# ADDENDUM NUMBER 1

**Title:** Katy Depot – Liberty Park Connect Sedalia Project  
**Owner:** City of Sedalia, Missouri  
**Engineer:** Wilson & Company, Inc., Engineers & Architects

ISSUE DATE: **September 16, 2025.**

**SHEET NO:**  
14 OF 80

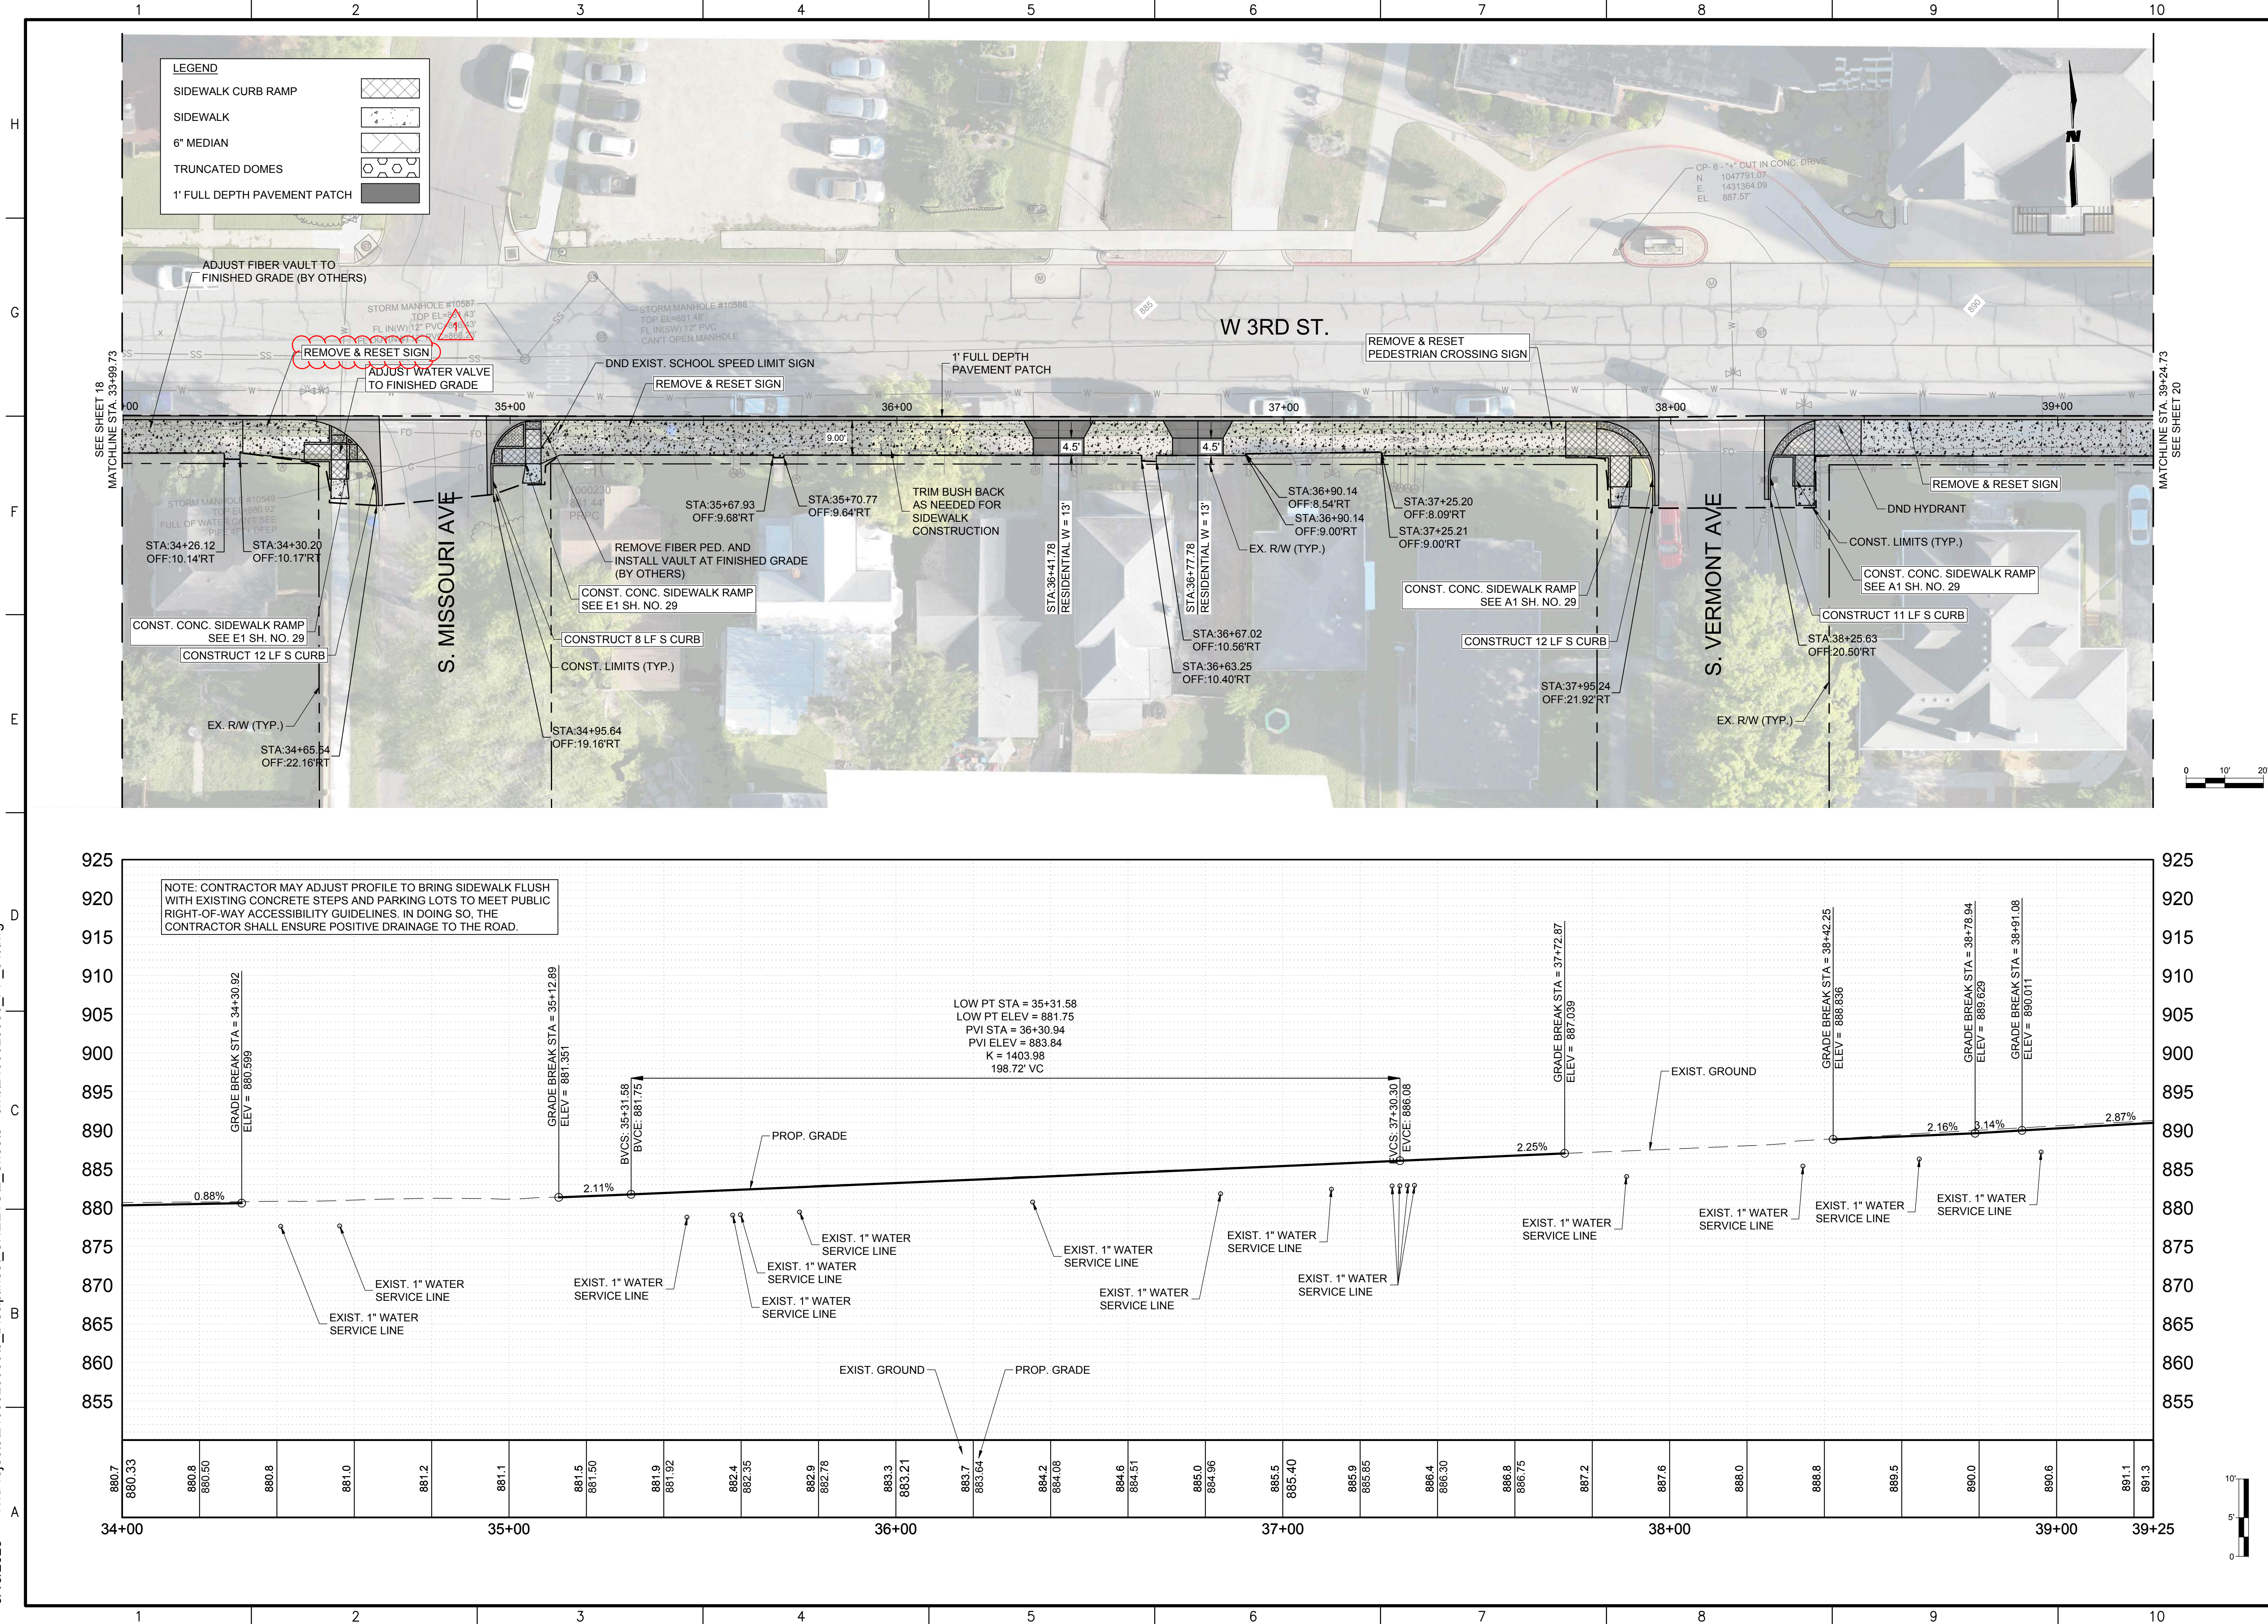
1. Plan Sheet #2; general note number 21 revised "sod" to "seeded" and bid item #25 quantity Remove and Reset Sign from 7 to 22.
2. Plan Sheet #14; Revised Location of Stop Bar going East on 3<sup>rd</sup> Street.
3. Plan Sheet #18; Added notes for removal and reset of an existing sign.
4. Plan Sheet #19; Added notes for removal and reset of an existing sign.
5. Plan Sheet #20; Added notes for removal and reset of an existing sign.
6. Plant Sheet #21; Added notes for removal and reset of an existing sign and removal of existing storm structure on southeast corner of 3<sup>rd</sup> Street and Osage Avenue.
7. Plan Sheet #46; Added Trench Drain detail.

### TYPE S CURB DETAIL

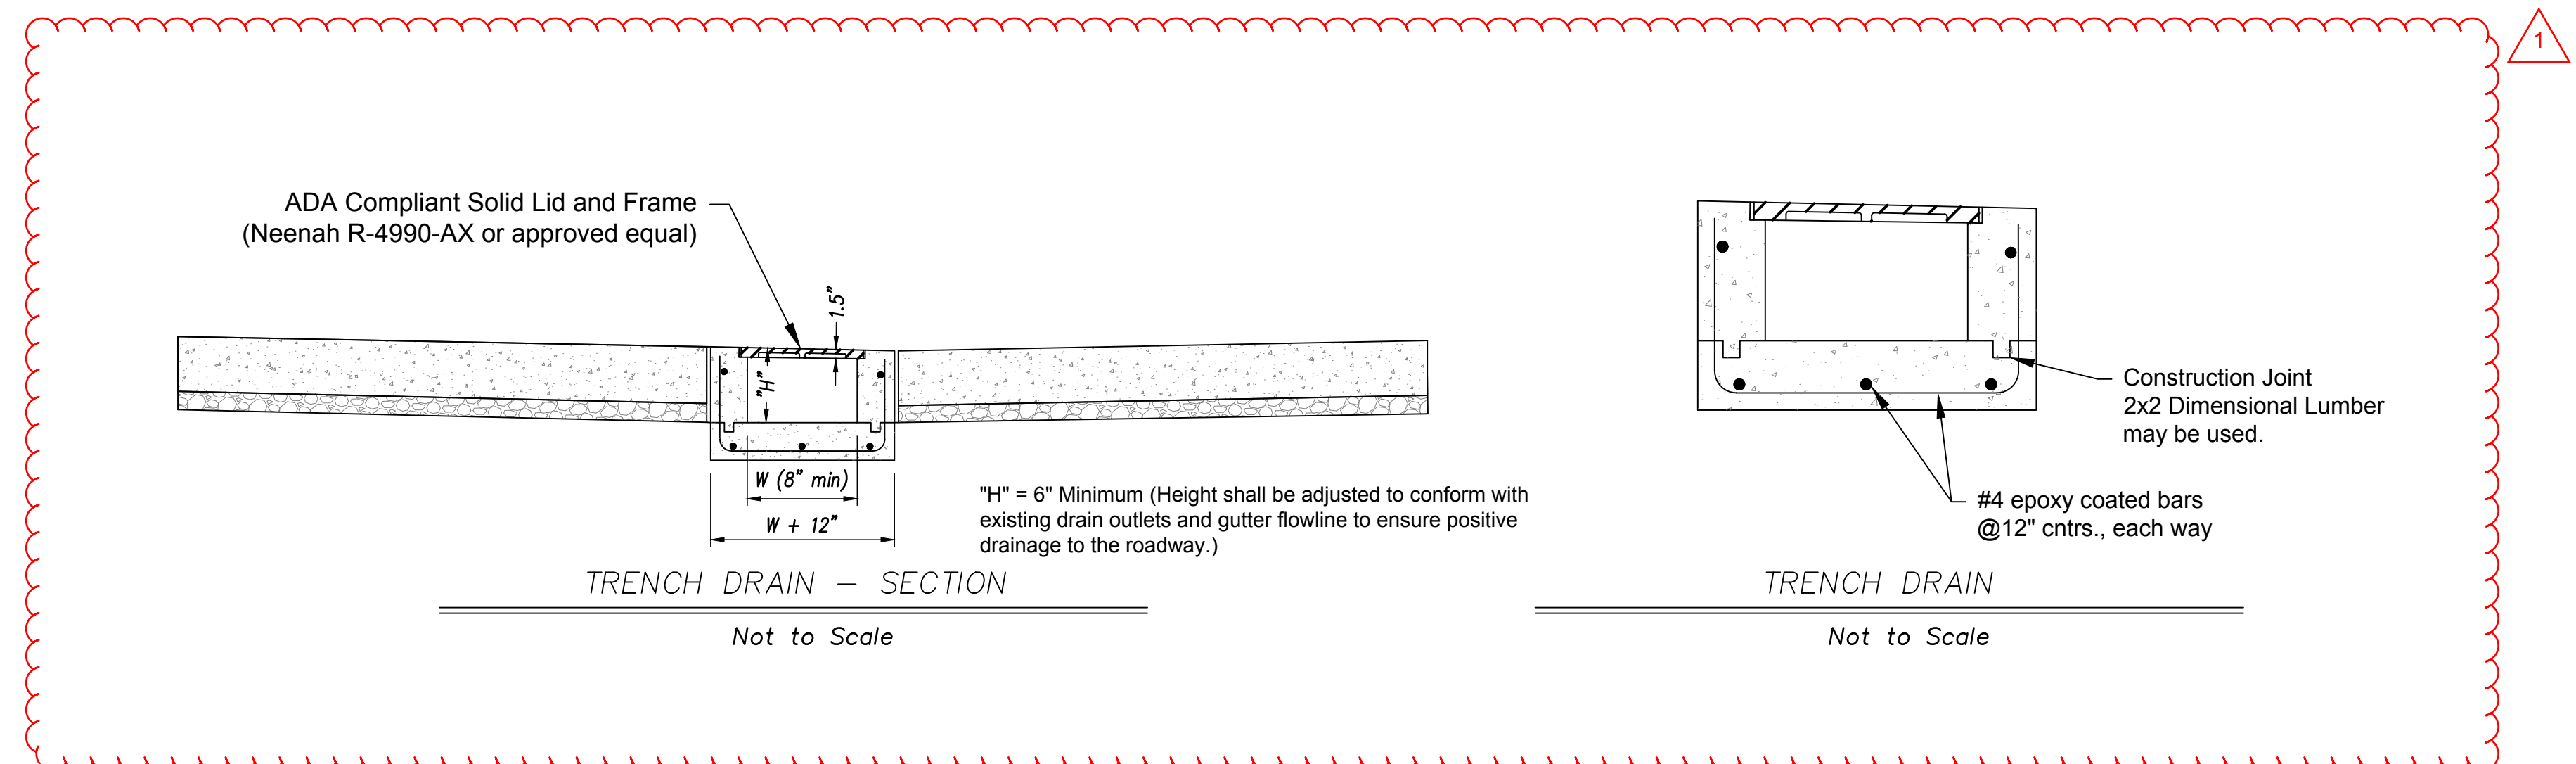
**Answer: A detail has been added to the miscellaneous detail sheet. This work shall be considered subsidiary to the sidewalk construction.**
